Project Name: BARLEE RD, 3 x 5-Plex  
 Project Title: SITE PLAN & ELEVATIONS

PROJECT TITLE  
**BARLEE ROAD  
15 UNIT ROW HOUSING**  
Kelowna, BC

**Date:** October 24, 2016  
**File No.:** Z16-0052  
**To:** Community Planning (TB)  
**From:** Development Engineering Manager(SM)  
**Subject:** 1925 Barlee Rd & 2160 Vasile Rd RU1 - RM5

SITE PLAN 1/16" = 1'-0"

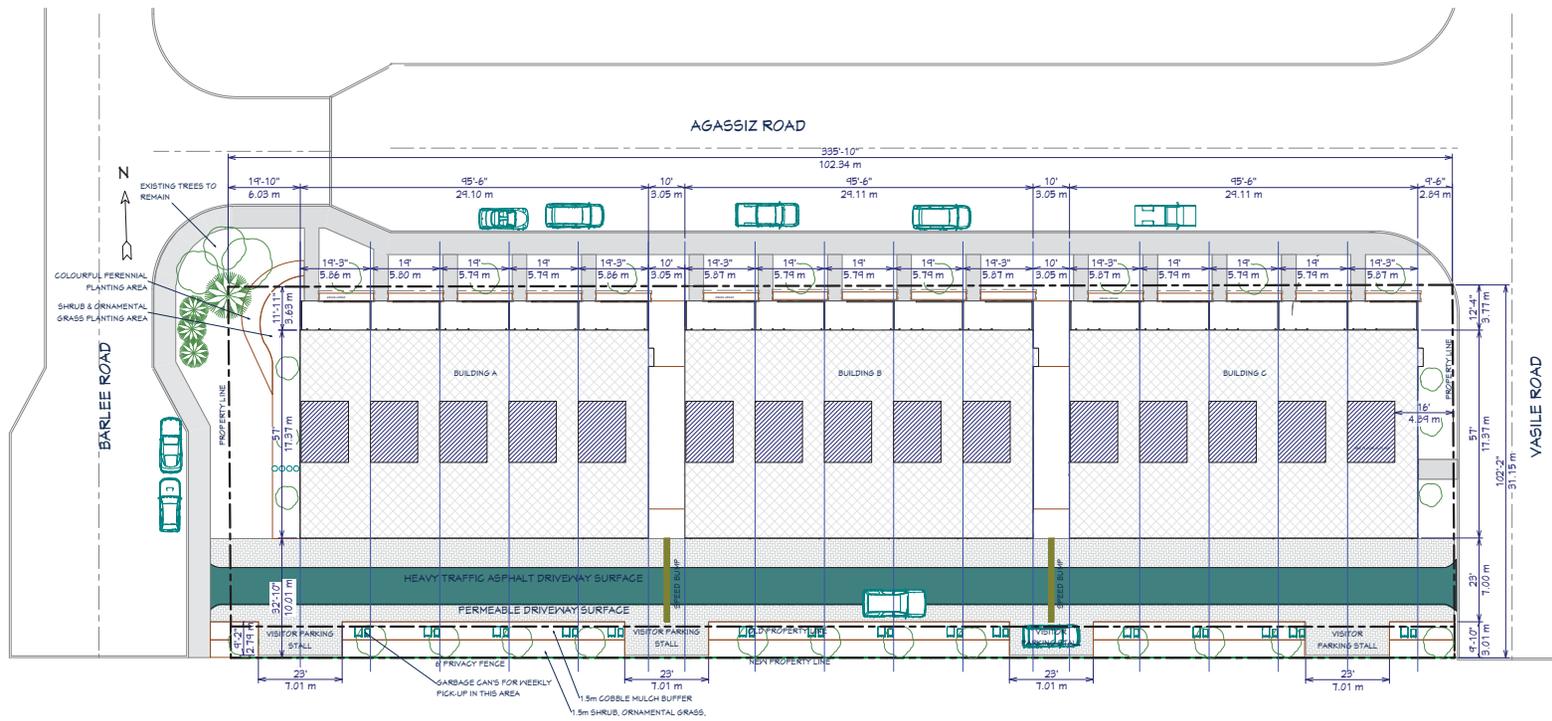
- (i) Access to the site will be permitted from Barlee Rd.
- (ii) Indicate on the site, the locations of the garbage and recycle bins.
